AIRSPACE DETERMINATION

CIVIL AVIATION REUSE OF

MARINE CORPS AIR STATION EL TORO

Airspace Determination for Proposed Civilian Reuse of the Former Marine Corps Air Station El Toro, California

FIGURE 2 – LOCAL REDEVILOPMENT AUTHORITY'S
PROPOSED AIRPORT LAYOUT PLAN
FOR THE FORMER MARINE CORPS AIR STATION EL TORO, CALIFORNIA

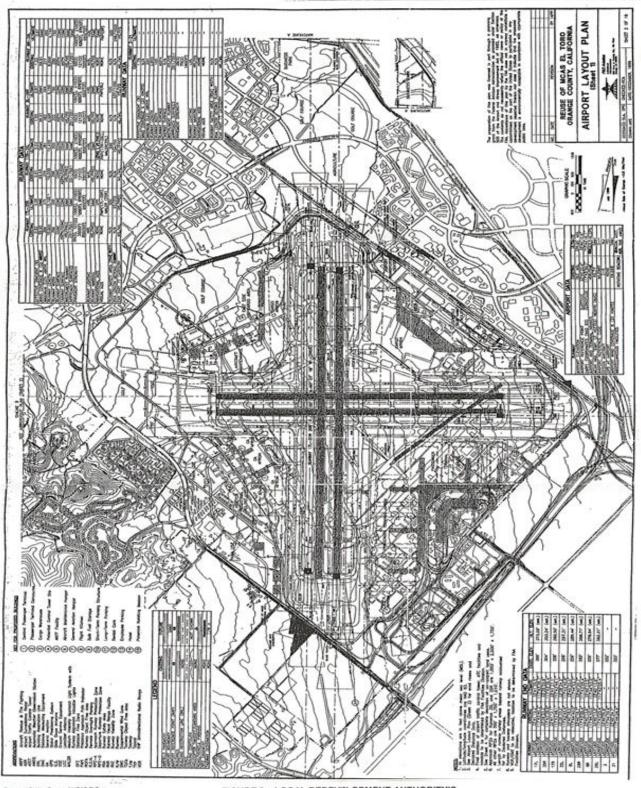
The FAA notes that the proposed ALP uses the ultimate runway magnetic heading designations for the runways at the former MCAS El Toro. This change in runway identification is due to the annual rate of change of the magnetic declination in the vicinity of the airport. For the purposes of this airspace determination the designation of the existing Runway 7L/25R and Runway 7R/25L is understood to be Runway 8L/26R and Runway 8R/26L, respectively. Runway 16R/34L and Runway 16L/34R is understood to be Runway 17R/35L and Runway 17L/35R respectively. Runway 3/21 does not change designation because the ALP indicates it is to remain closed to all operations.

The existing effective longitudinal gradient for Runway 8L/26R and 8R/26L is 1.55 and 1.53 percent, respectively. The FAA standard for effective longitudinal gradient for Aircraft Approach Categories C and D is \pm 1.5 percent (reference paragraph 502(a)(2) of FAA Advisory Circular 150/5300-13). The aircraft flight manuals for typical transport category aircraft (i.e. Boeing 727) indicates that the aircraft is certified to be able to perform takeoff and landing operations on runways with a slope of \pm 2 percent. The performance data for a typical McDonnell-Douglas aircraft (now owned by Boeing) such as the MD 90 or Boeing 717 indicates that this aircraft is certified for takeoff operations using a runway with a + 1.7 and – 2 percent slope and \pm 2 percent slope for landing operations. Therefore, based on this information, it is reasonable to conclude that transport category aircraft can safely operate using the existing runways.

The proposed ALP also indicates that the existing effective longitudinal gradient (slope) for Runways 17R/35L and 17L/35R is .62 and .61 percent, respectively, which meet FAA design standards. According to the LRA's master plan, following the base transfer and initiation of civilian operations, the LRA proposes to reconstruct one of each of the two pairs of parallel runways to meet minimum FAA separation standards for runway to runway centerline. In addition, both runways 8L/26R and 8R/26L would be reconstructed so that the longitudinal gradient would meet FAA design standards. The ALP depicts the proposed future gradient for Runways 8R/26L and 8L/26R to be .91 and .87 percent, respectively which would be consistent with FAA standards.

Considering the runway centerline separation distances for both pairs of runways and the longitudinal gradients for the 8/26 pair of runways that currently do not meet FAA design criteria, the FAA considered the need for a Modification to Airport Design Standards consistent with Paragraph 6 of FAA Advisory

MCAS El Toro has not received federal aid from the FAA for airport development. The proposed ALP, submitted by the LRA to the FAA for review indicates that the proposed reuse of the military airport includes proposed changes to the airfield to meet FAA design standards. Therefore, based on this information, the FAA has determined that a Modification of Airport Design Standards for the initial non-standard runway centerline to parallel runway centerline separation and the effective runway gradient is not necessary. Conversely, a Modification to Airport Design Standards would be appropriate if the LRA proposed to permanently retain the non-standard runway centerline to runway centerline separation and effective longitudinal gradients rather than change them as depicted in their ALP.

In summary, FAA's review of the ALP, considers both the existing and ultimate layout of the proposed civilian aviation reuse at MCAS EI Toro. As documented above, the operational flight manuals for various commercial service aircraft indicate that these aircraft can safely operate using runways with longitudinal gradients that currently exist at the former MCAS EI Toro. The FAA's review of the proposed ALP and development depicted thereon indicates that the ultimate layout for proposed civilian reuse MCAS EI Toro can meet the minimum FAA airport design standards.

Figure 6. Comparison of Original and Revised Runway 35 Departure Procedures at ELB

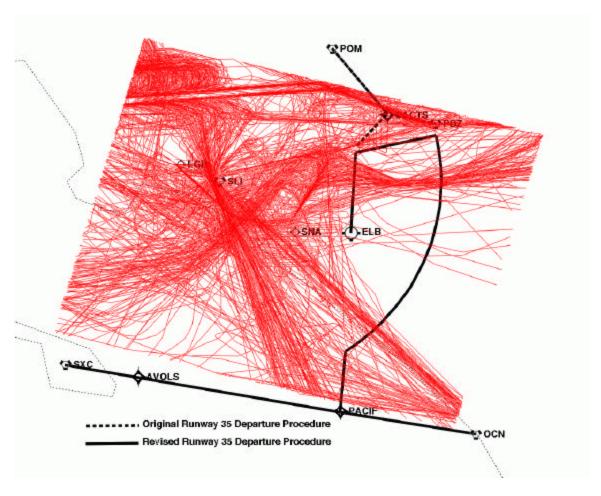
The arrival and departure procedures presented in this document are similar to those procedures analyzed previously. One significant difference is the runway 35 departure procedure will climb through airspace currently reserved for John Wayne Airport – Orange County (SNA) and Long Beach Municipal Airport (LGB) arrivals. The original and revised departure procedures are depicted along with SCT arrival radar tracks in figure 6 below:

In both the original and revised procedures, runway 35 departures climb and maintain runway heading until reaching the vicinity of the SLI 061 radial. The original procedure took departures to CACTS and then to either the POM or PDZ transition. The revised procedure takes departures along the SLI 061 radial until reaching 27 DME from SLI, and departures follow the 27 DME SLI arc South until eventually reaching PACIF and transitioning at SXC or OCN. While these procedures have very different flight paths and transitions, they both require departures to climb through airspace currently set aside for arrival traffic.

Both transitions (SXC and OCN) for the PACIF ONE departure are south of the airport. As a result, northbound departures from runways 35 and 17 under this new procedure will experience an increase in flight distance over the original departure procedures with transitions north of the airport. However, this modification mitigates an airspace conflict between ELB departures to POM and LAX arrivals.
